HYDROLOGY K15/D30B 1 PLAN

Re: Drainage Plan Submittal of
Edward/Rodgers Building (K-15/D30B)

RE: DRAINAGE PLAN SUBMITTAL OF EDWARDS/ROGERS BUILDING
RECEIVED JUNE 23, 1986 FOR BUILDING PERMIT APPROVAL
(K-15/D30B)

RE: DRAINAGE PLAN SUBMITTAL OF EDWARDS/ROGERS BUILDING
RECEIVED MAY 9, 1986, FOR BUILDING PERMIT APPROVAL
(K-15/D30B)

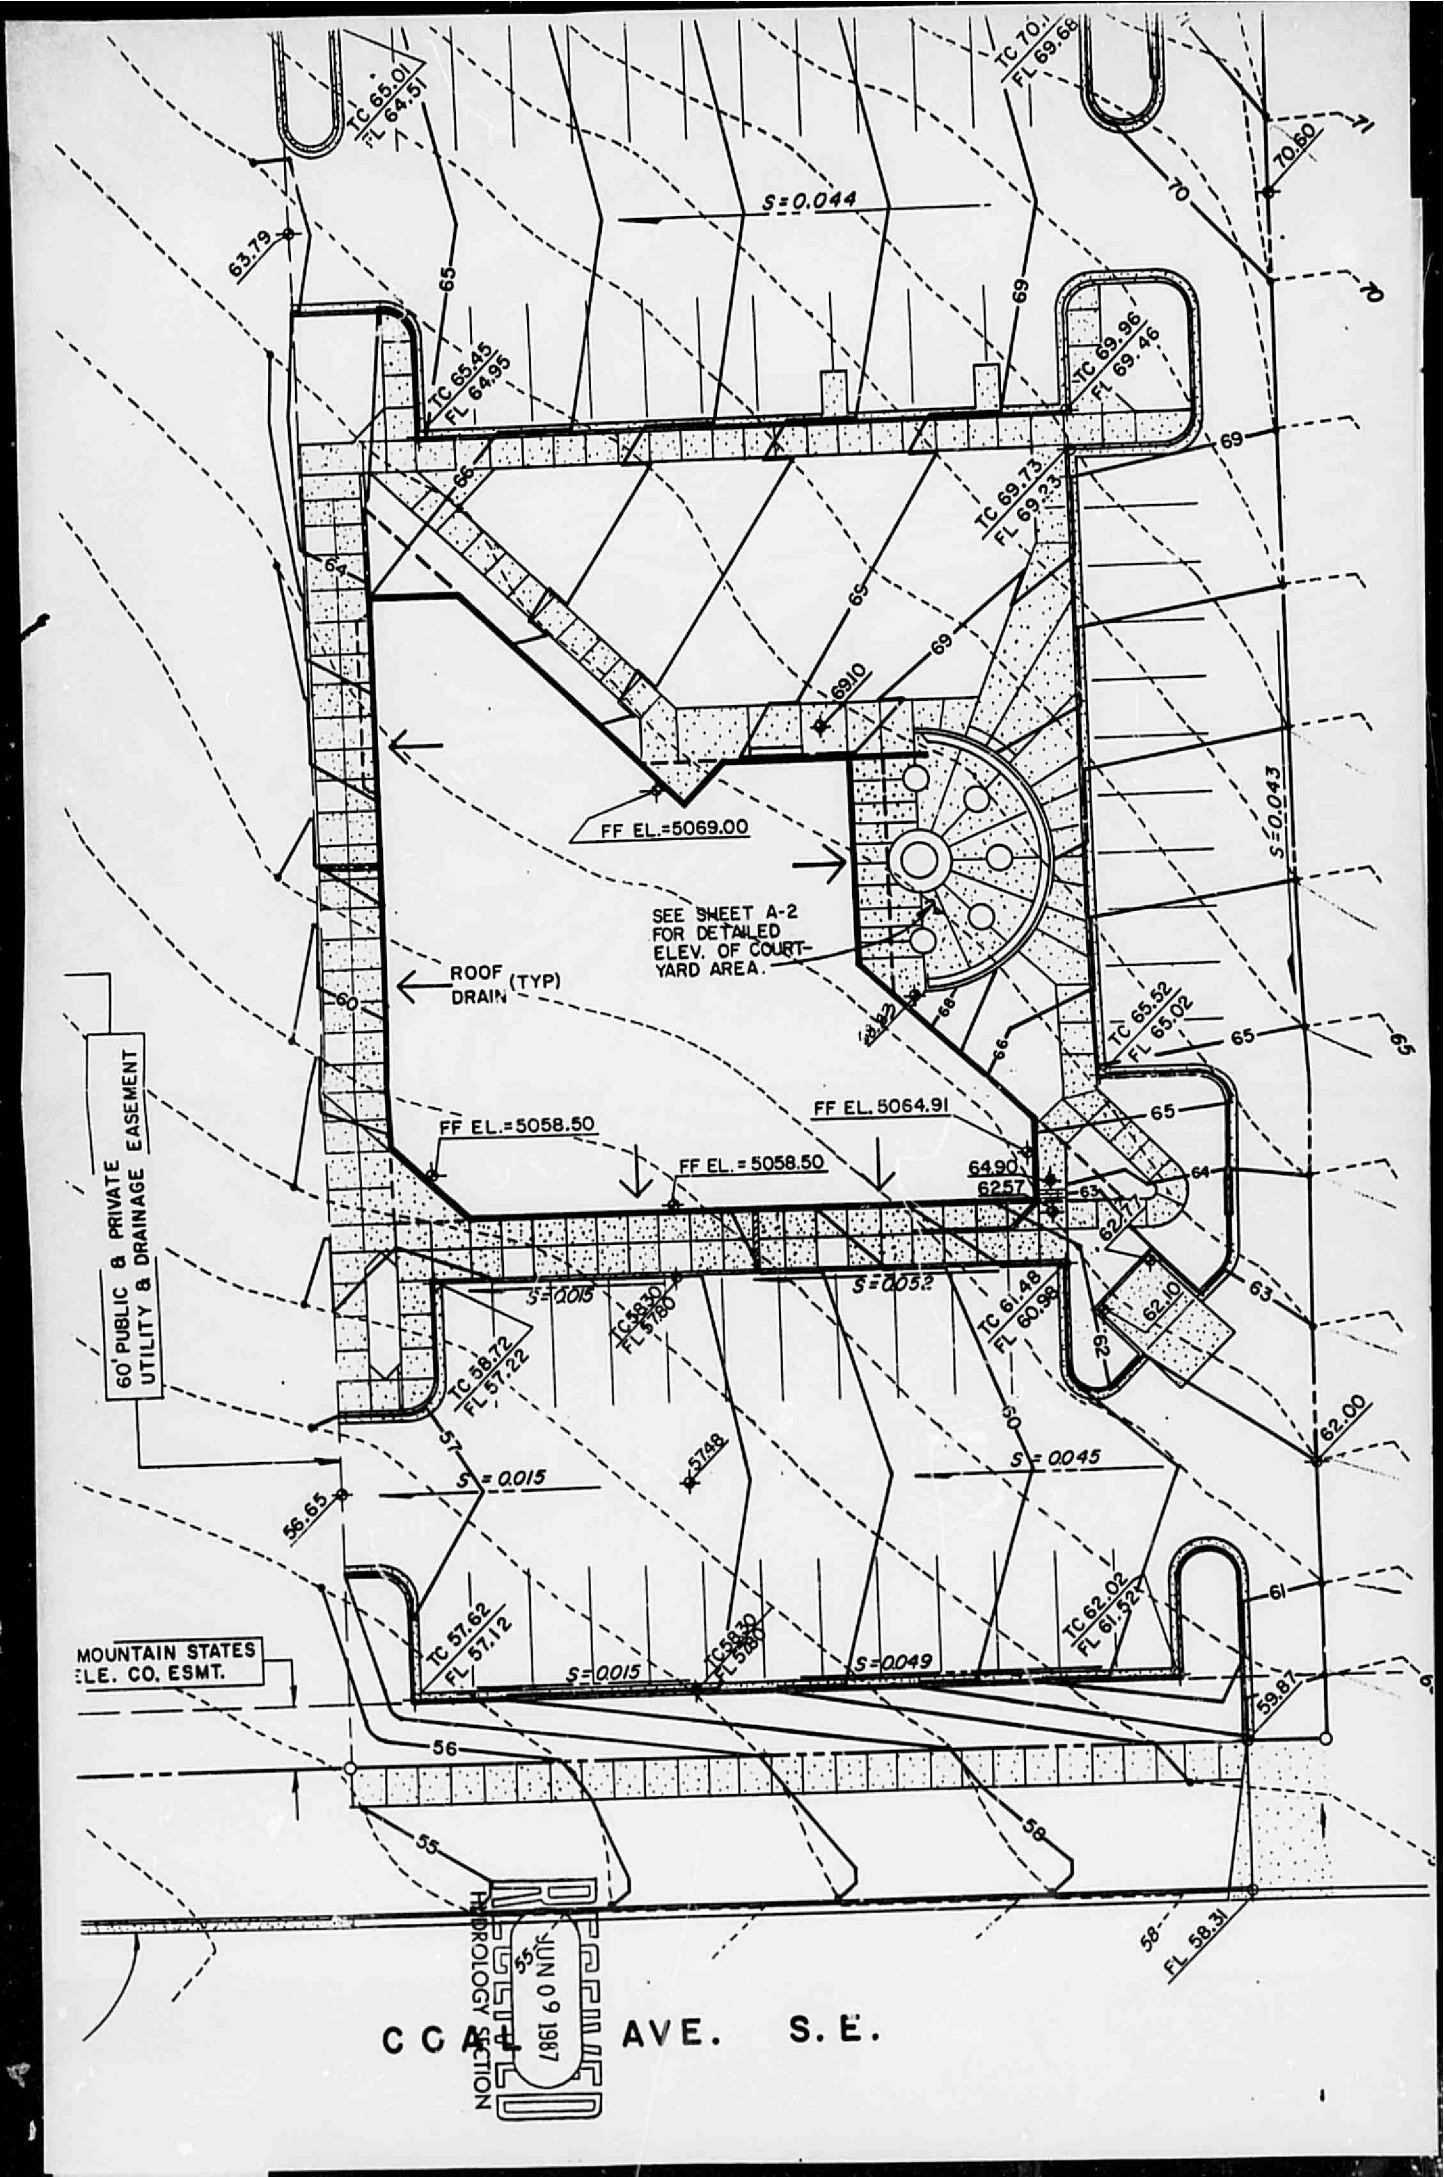
Verbal Comments to Jackie McDowell. Need interim, Drainage Treatment from North & South Parking Lots to discharge into Coal Ave. This Building Permit must stand alone, Resubmittal required.

6/16/86
Will also need Drainage easements to accept Drainage flow from the east. Site to East did not follow approved Grading Plan.

1. Private drainage easements are required from Tract "C" and Tract "D" to allow discharge from Tract "B-1" across these properties. These Drainage Easements can be separate or combined and should include signature blocks for City Engineering and Legal staff review and concurrence.
